In the Matter of	)	
	)	
LONG ISLAND LIGHTING COMPANY	)	Docket No. 50-322-0L
	)	
(Shoreham Nuclear Power Station,	)	
Unit 1)	)

JOINT TESTIMONY  
of  
CARL H. BERLINGER, SPENCER H. BUSH,  
ADAM J. HENRIKSEN, WALTER W. LAITY, AND PROFESSOR ARTHUR SARSTEN  
on  
CONTENTIONS CONCERNING TDI EMERGENCY DIESEL GENERATORS  
at the  
SHOREHAM NUCLEAR POWER STATION

EXHIBIT 2

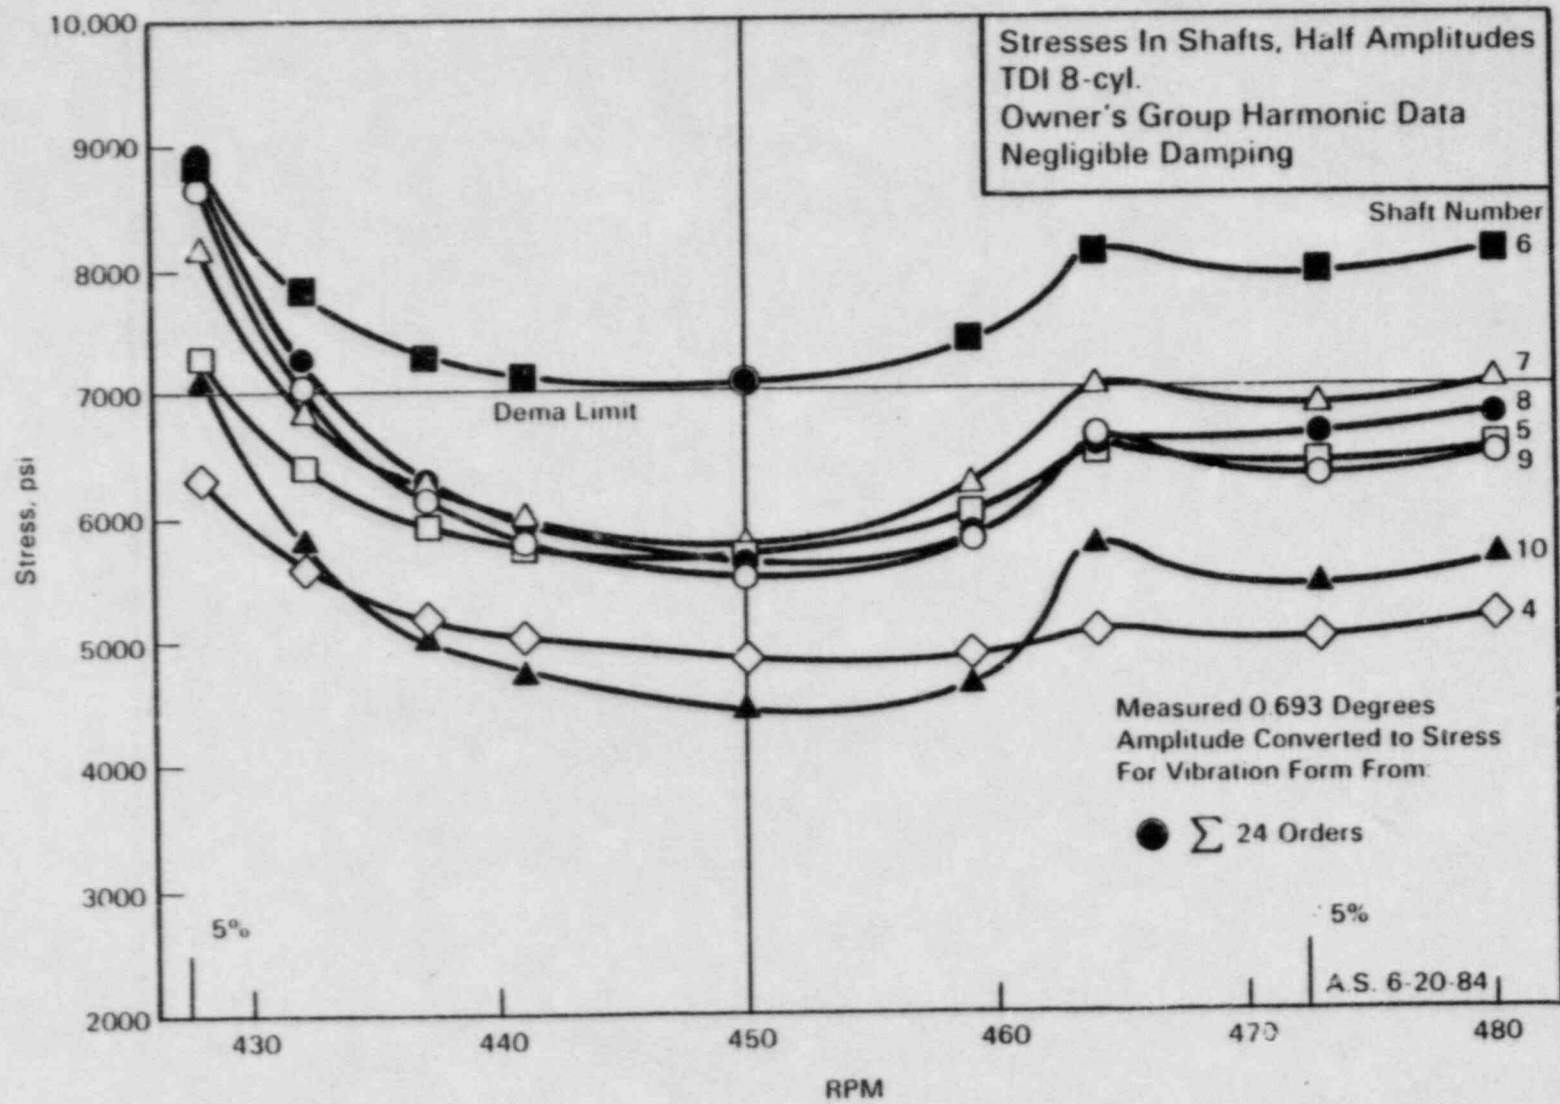
A. (Sarsten) Yes. These results are plotted in Exhibit 2. My analysis is for engine operation at 3500 kW, and employs the same  $T_n$  values (TDI Owners' Group harmonic data) used by FaAA. The results are preliminary, and are subject to some slight refinements and checks. However, I anticipate that any changes in my results are unlikely to affect my conclusions to any significant degree.

For Section No. 6 of the crankshaft (i.e., the torsional spring representing the crankshaft elasticity between cylinders 5 and 6), my analysis shows that the stresses for the sum of all orders exceed the DEMA limit of 7000 psi over the entire speed range called for by DEMA, i.e., from 5% below rated speed to 5% above rated speed.

EXHIBIT 3

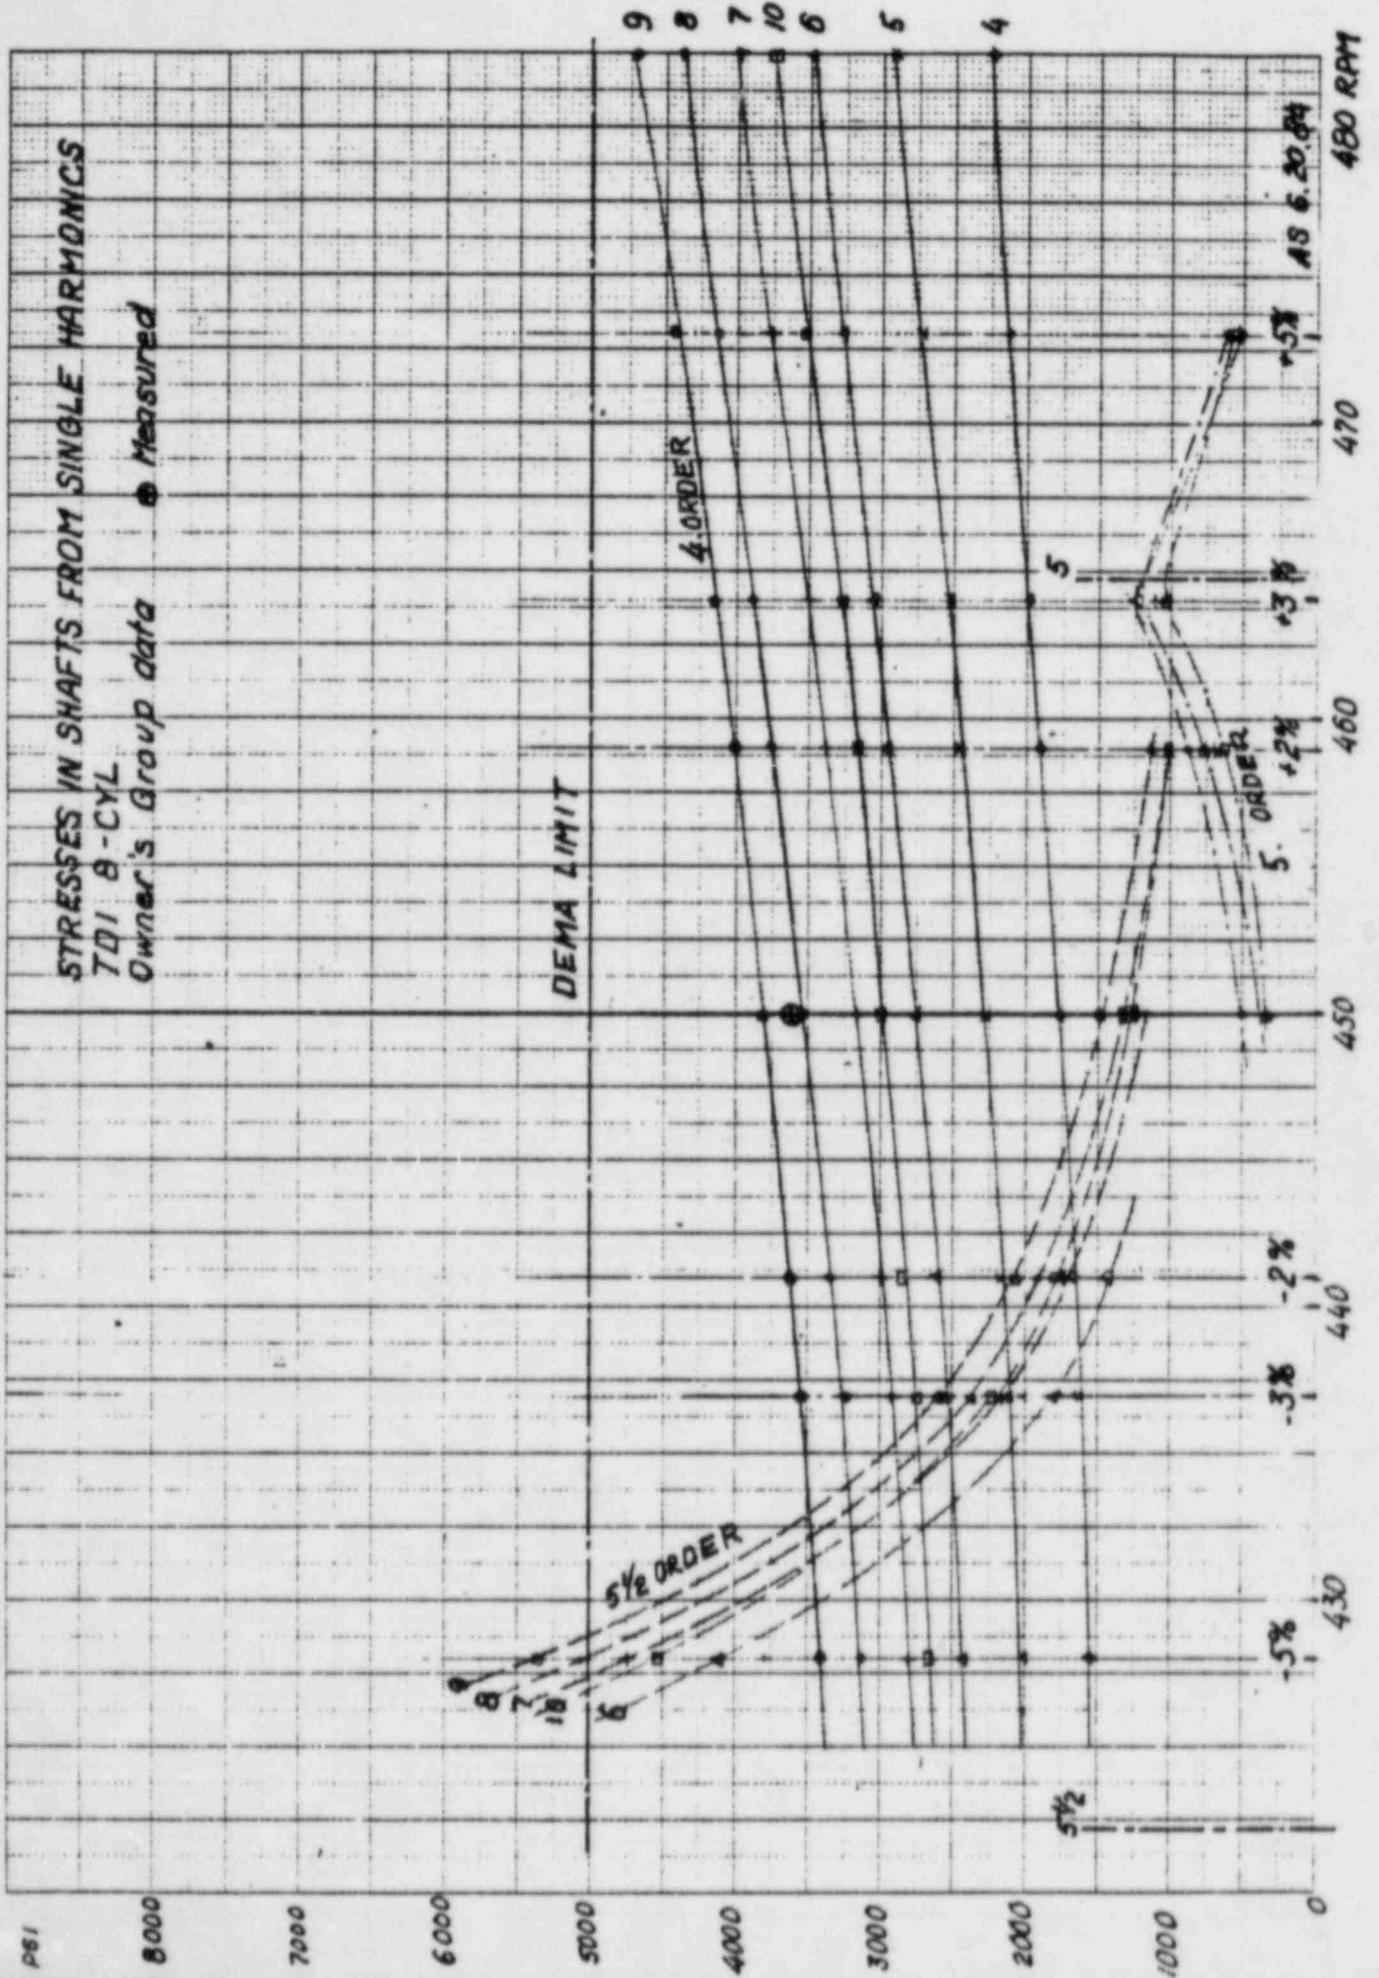
A. (Sarsten) Yes. These results are plotted in Exhibit 3. At the rated speed of 450 rpm, the maximum torsional vibratory stress in the crankshaft occurs for the 4th order. My calculated value for this stress at 450 rpm is approximately 3800 psi. Values of this stress remain below the DEMA limit

of 5000 psi throughout the speed range called for by DEMA. The rise of the 5 1/2 order above the 5000-psi limit at 95% of rated speed is not considered important, as the actual stress values so near resonance will depend upon the damping values assumed. Thus, in my view, the crankshaft does meet the DEMA requirements for single orders.

**Fig 4 Incidence of Scuffing**

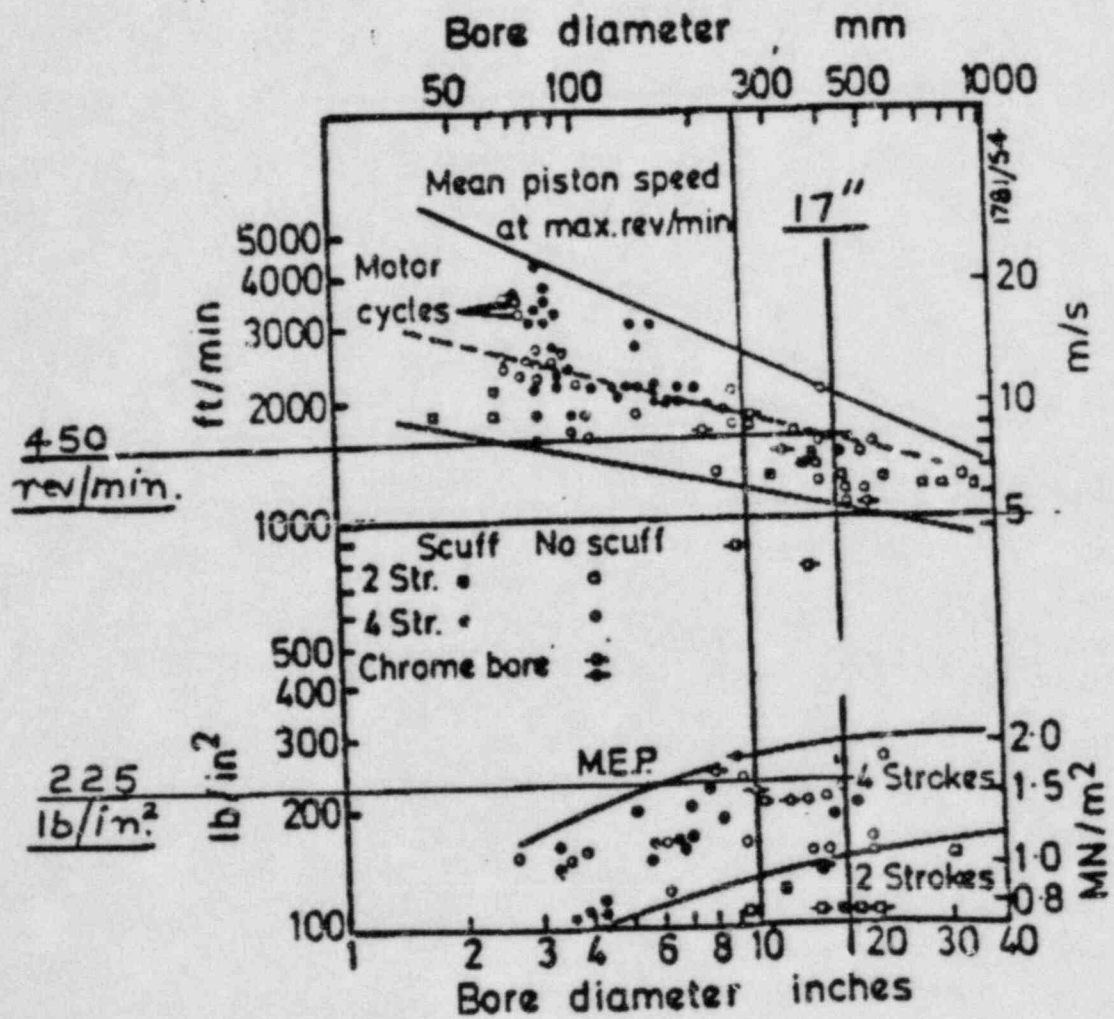
A GRAPH IS ENCLOSED, PAGE WHICH SHOWS PISTON SCUFFING SHOULD NOT OCCUR ON THIS ENGINE AT THIS RATING AND SPEED UNDER NORMAL CONDITIONS

WE USE THIS GRAPH FOR REFERENCE PURPOSES IN ASSESSMENTS AND TO ASSIST IN FUNDAMENTAL DESIGN DECISIONS ON NEW ENGINES. IT IS VERY DIFFICULT TO RELATE ENGINE RELIABILITY TO ENGINE SPEED ESPECIALLY AS ENGINE DEVELOPMENT VARIES CONSIDERABLY BETWEEN MANUFACTURERS. THE SURVEY DOES SHOW HIGH PISTON SPEEDS TO BE MORE PRONE TO SCUFFING.
